**Ojai Basin Groundwater Management Agency  
Meeting  
July 28, 2022  
3:00 pm**

# Addendum 1: Detailed responses to the SWRCB July 1, 2022 Comment Letter

# Addendum: Detailed responses to the Non-Governmental Organization Consortium April 30, 2022 Comment Letter

**FIGURE 11**  
 Ventura River Watershed GW-SW Model: Thickness of Model Layer 1  
 Ojai Valley Groundwater Basin

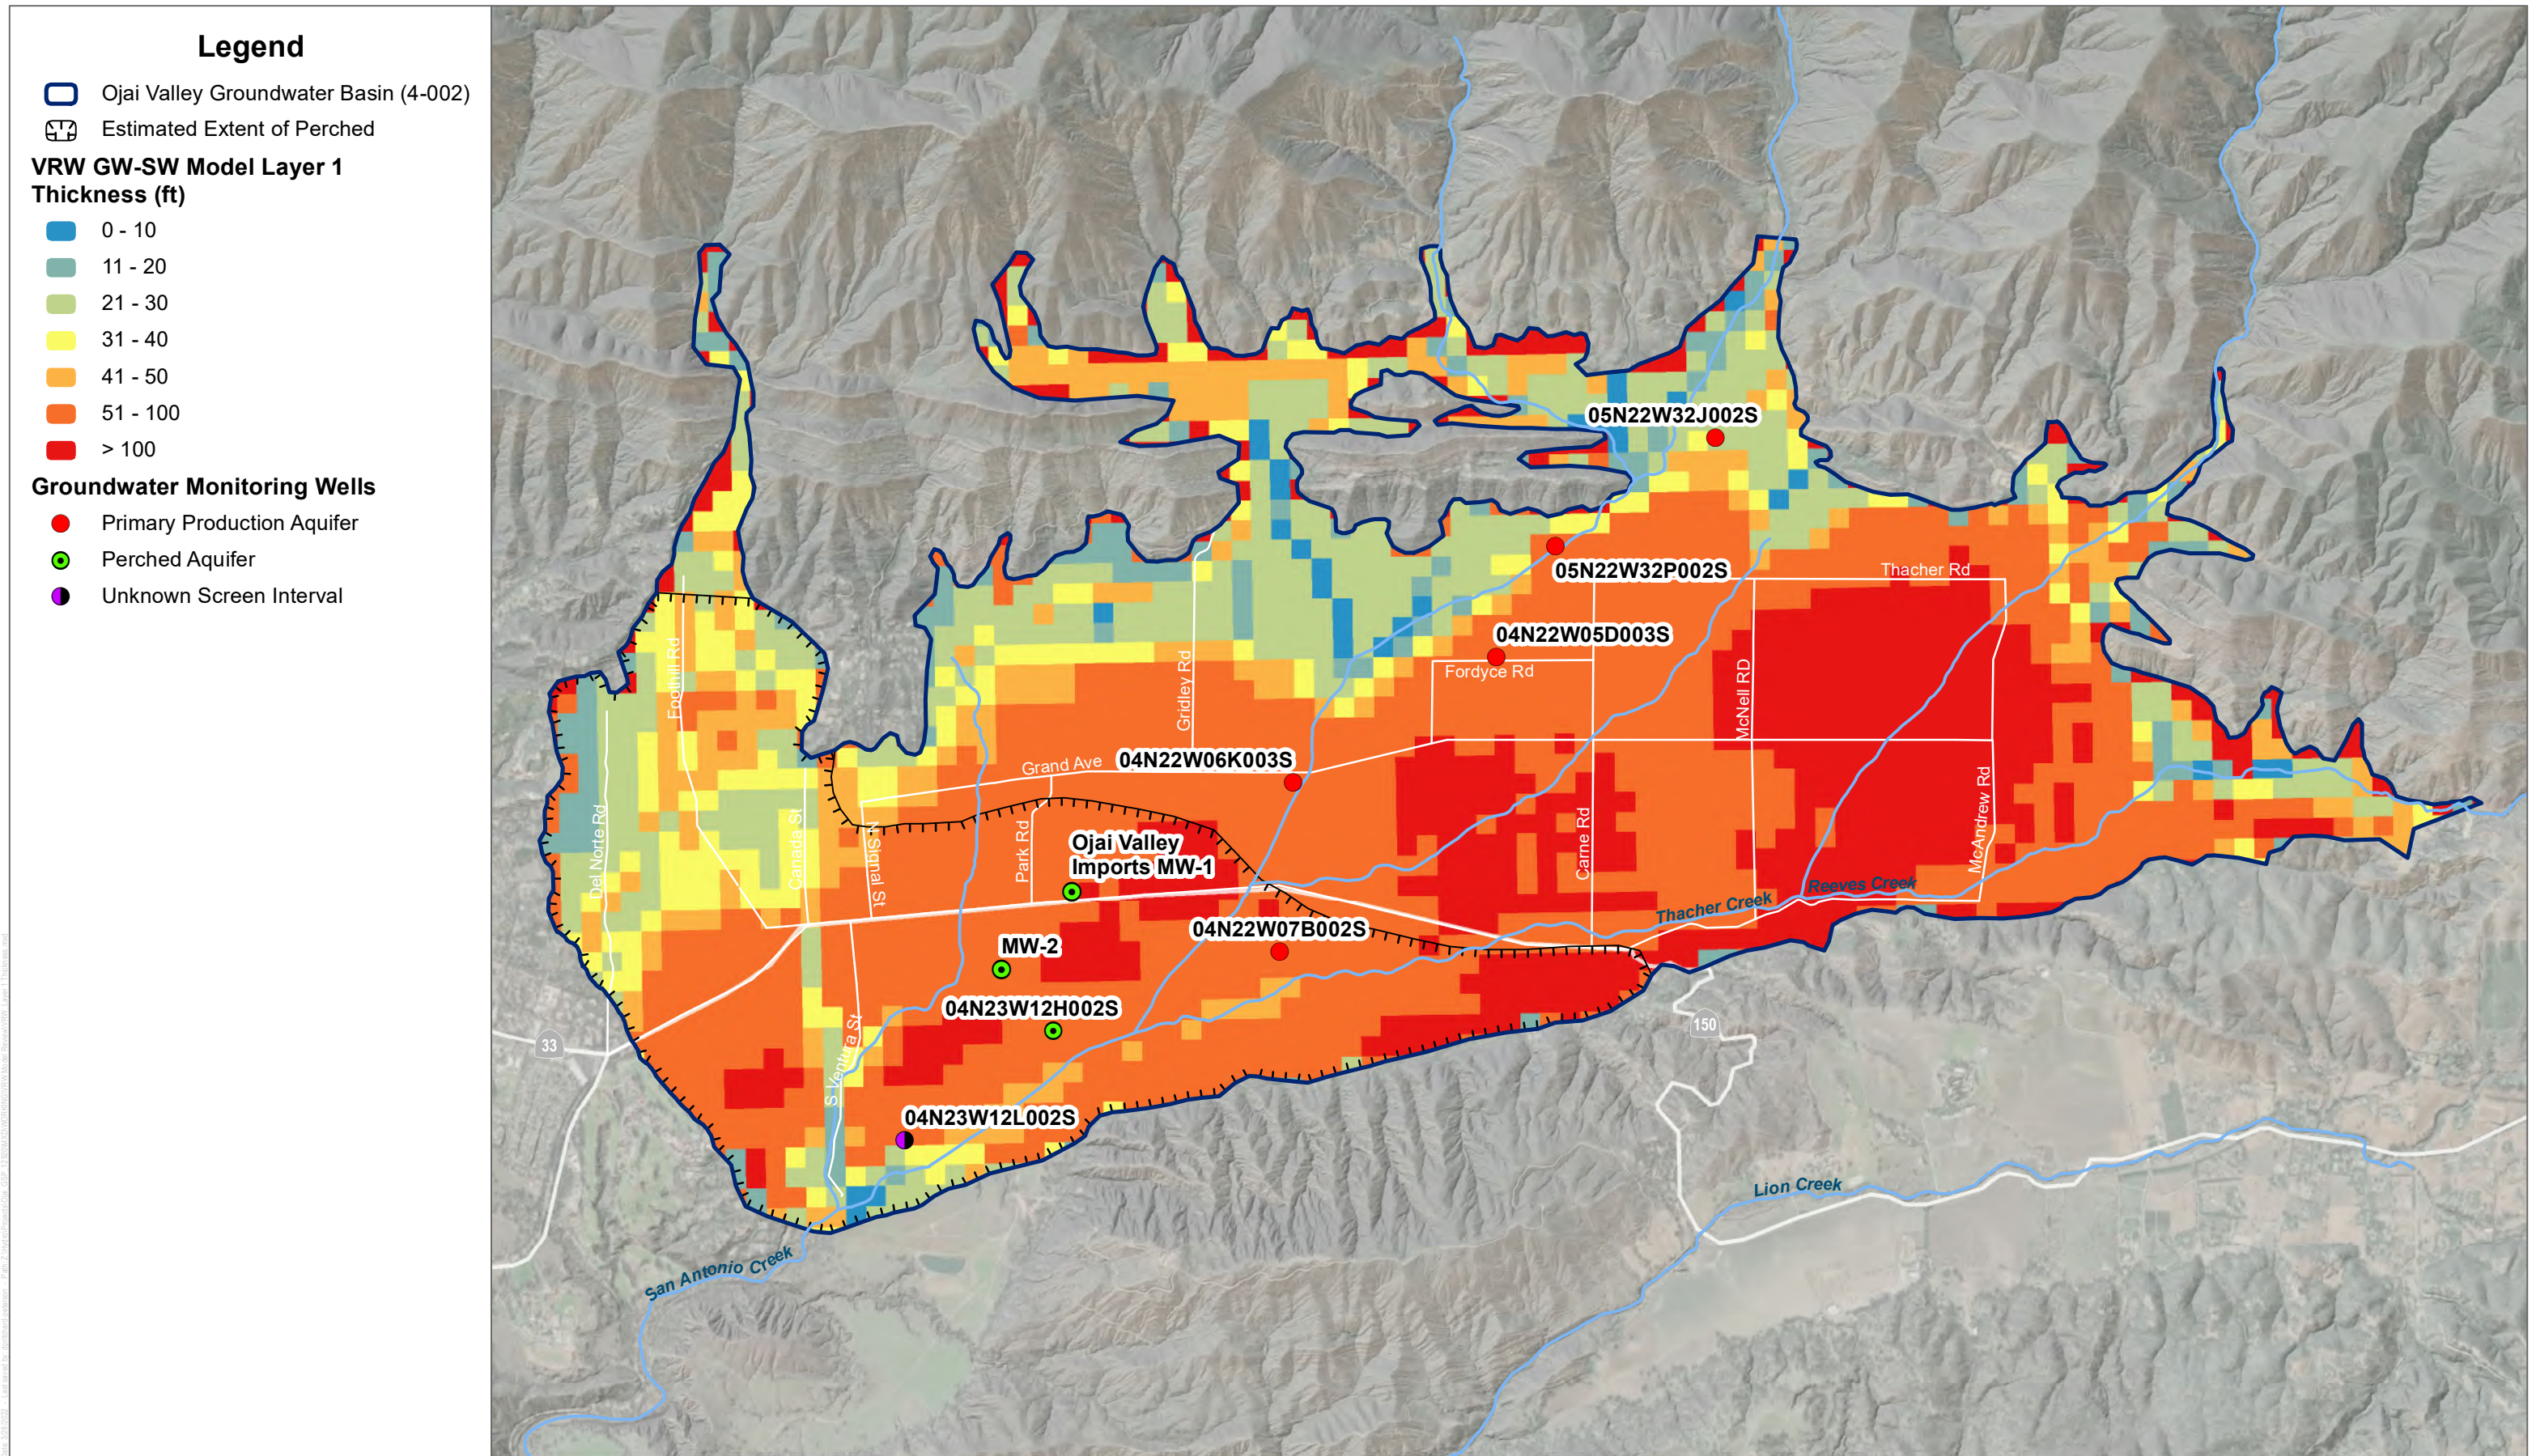
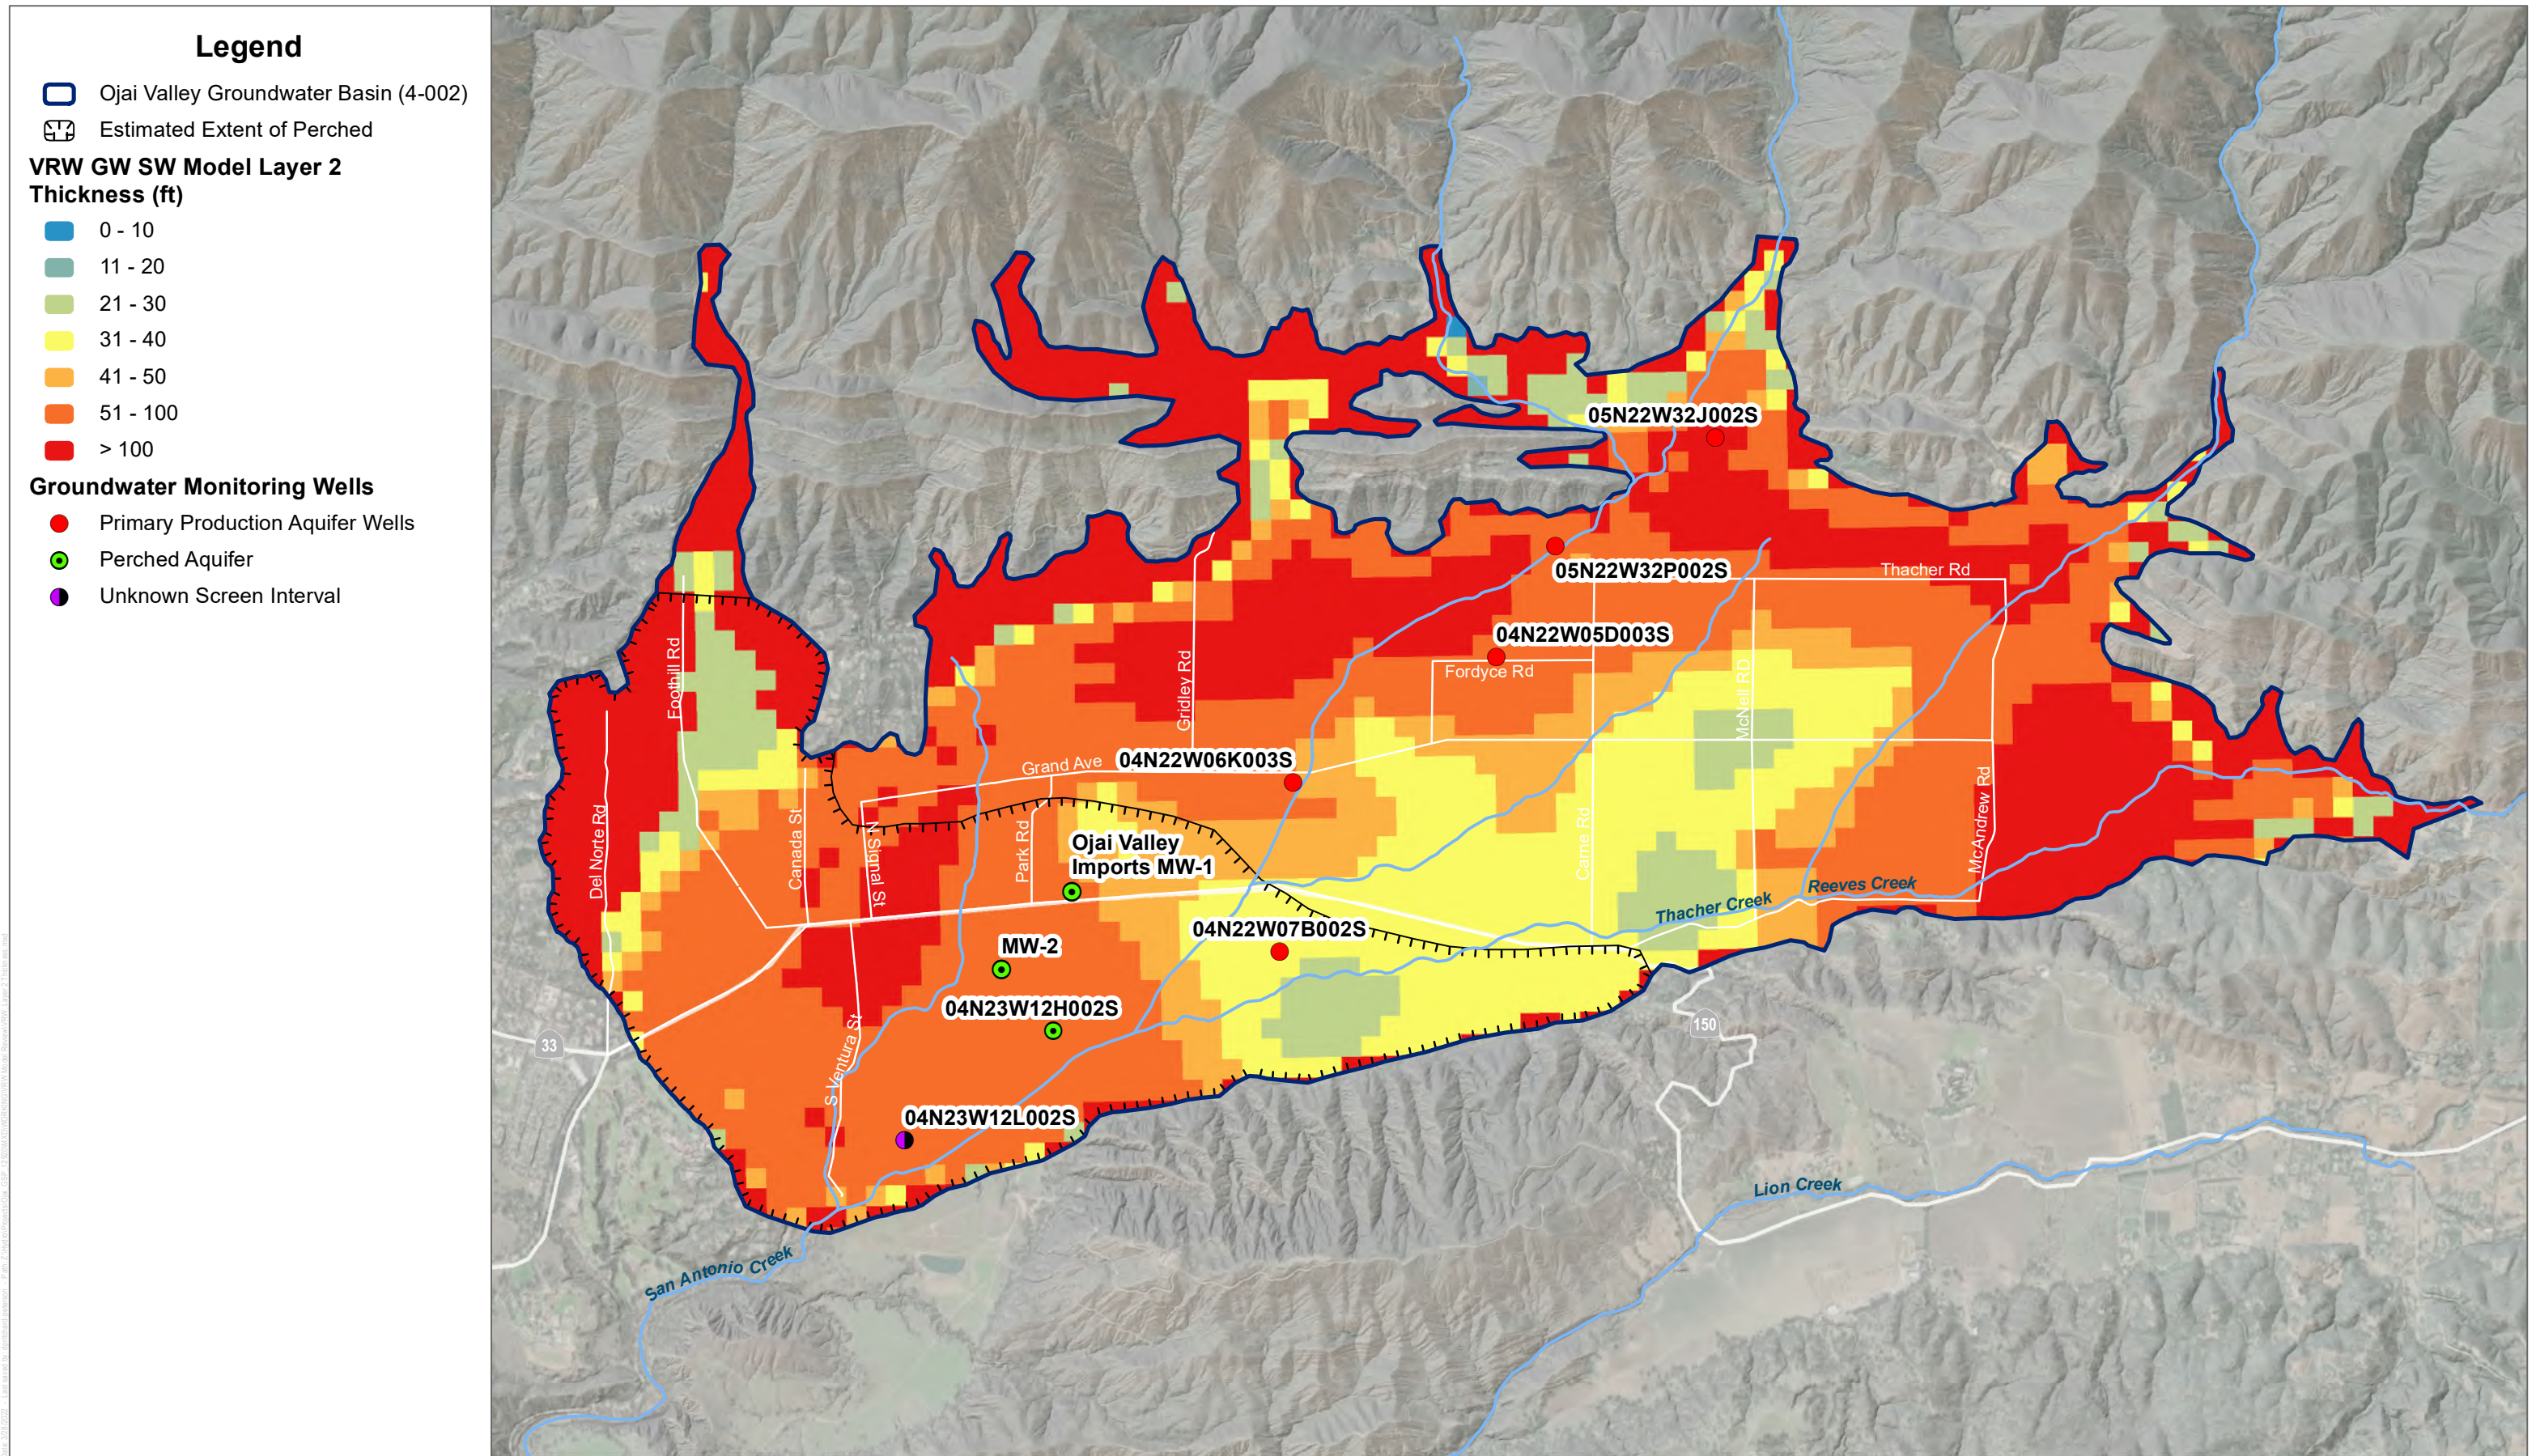
The VRW GW-SW model represents the aquifer in this part of the OVGB using six model layers that extend from land surface to depths that exceed 500 feet bgs. The upper layer in the VRW GW-SW model, which is numerically connected to San Antonio Creek, ranges in thickness from approximately 5 feet to greater than 100 feet (Figure 11) and is characterized using hydraulic conductivity values that range from approximately 0.1 to 20 feet per day. This range of hydraulic conductivity is orders-of-magnitude higher than published conductivity ranges for the unconsolidated clays encountered between the perched and primary production aquifer (Freeze and Cherry 1979). This upper layer is underlain by a second model layer that also ranges in thickness from approximately 5 feet to greater than 100 feet (Figure 12) and is characterized using similar hydraulic conductivity values as layer one.
